ENGINEERING NOTICE

Area Affected: Analog Gauge Mercury V8 Installations

Date Issued: 6/8/22

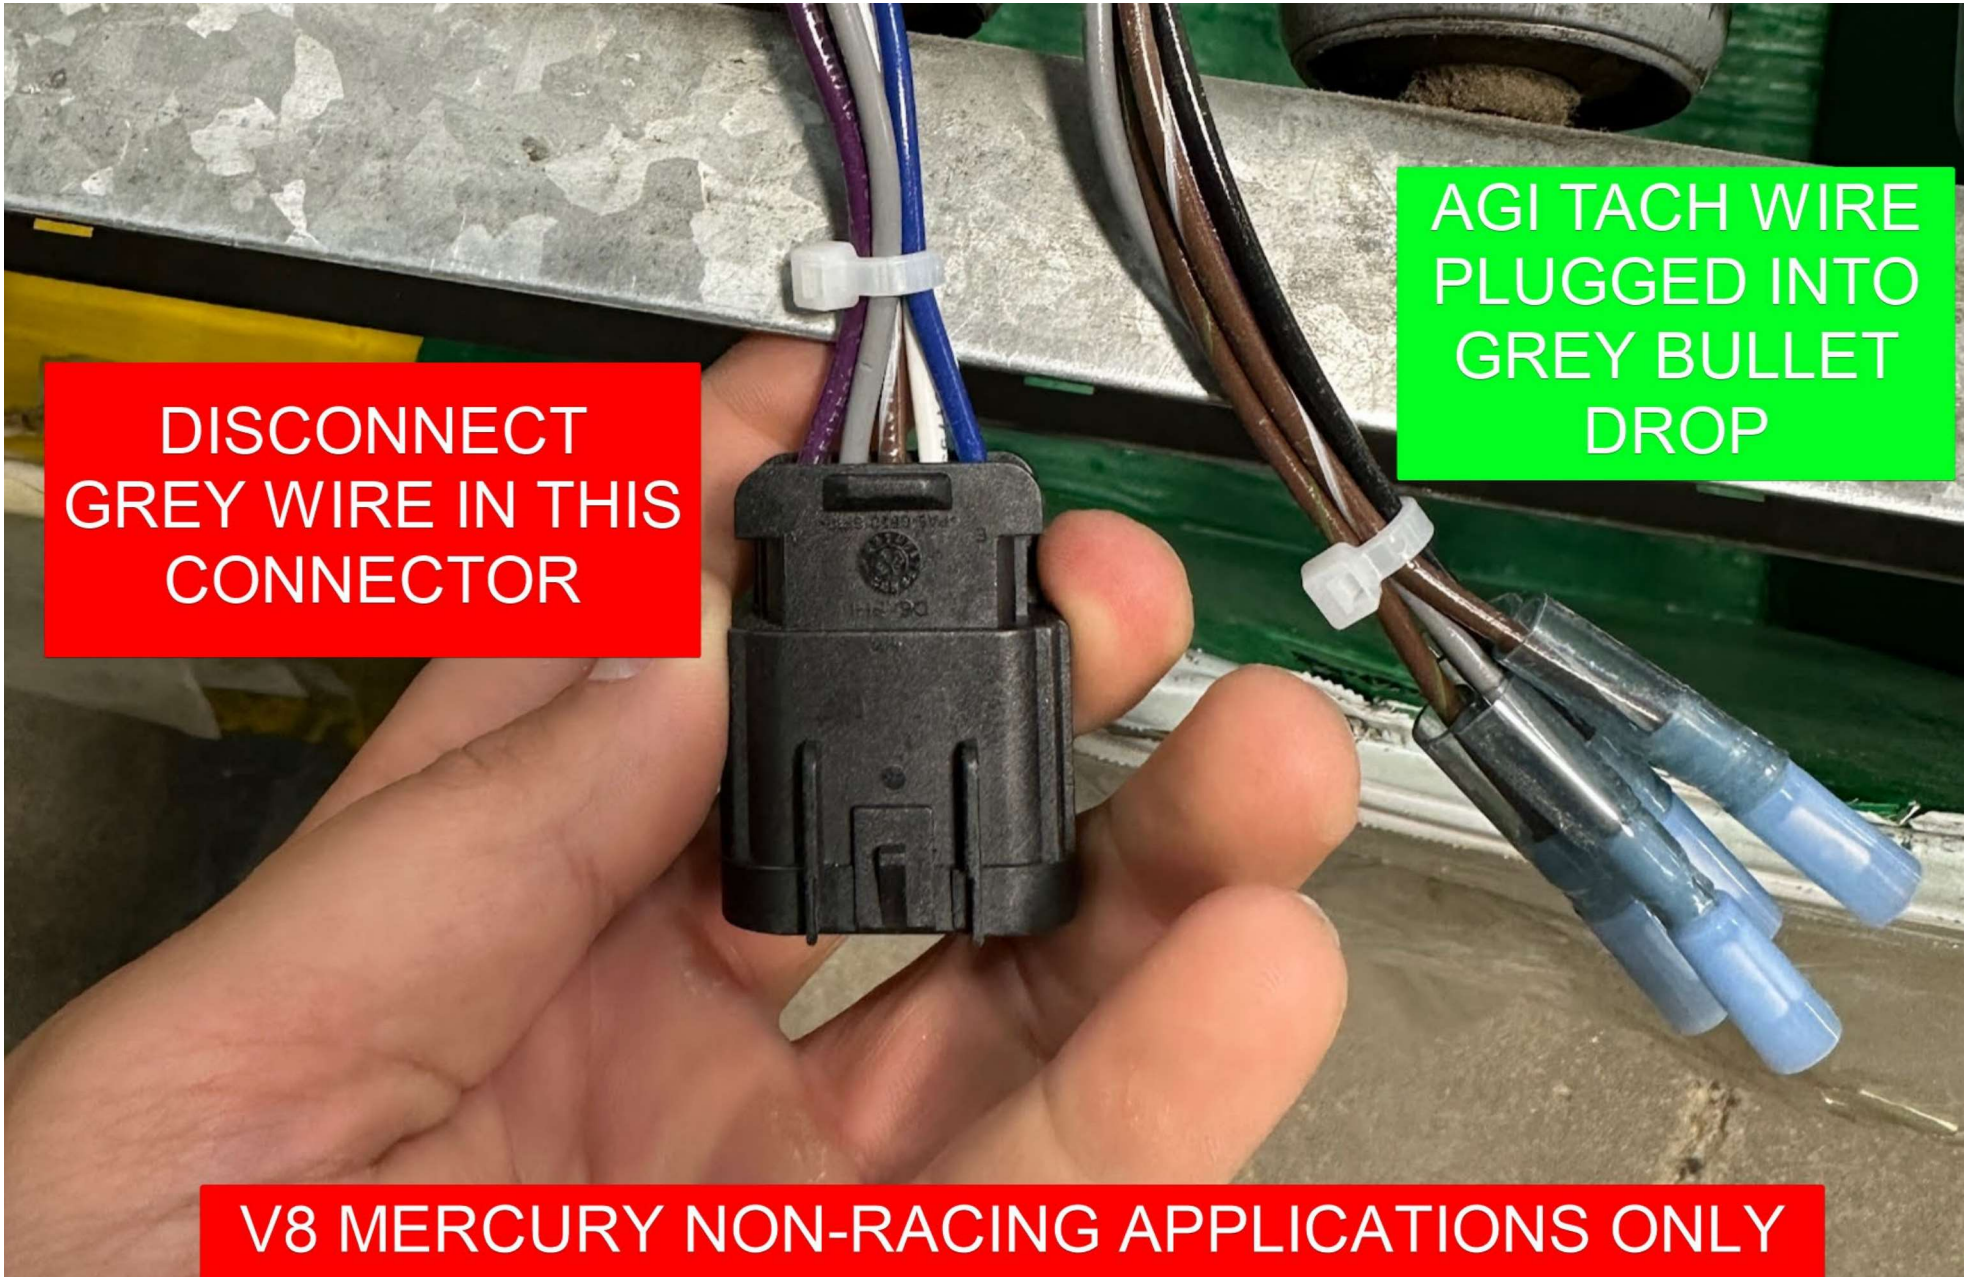
DISCONNECT
GREY WIRE IN THIS
CONNECTOR

AGI TACH WIRE
PLUGGED INTO
GREY BULLET
DROP

V8 MERCURY NON-RACING APPLICATIONS ONLY

Fix: Locate the Mercury connector found on the dash harness (found either plugged into the Mercury main harness or Mercury Junction Box) and disconnect the Grey tach wire. Ensure gauge is set to Mercury 150+. Please see page 2 for reference.
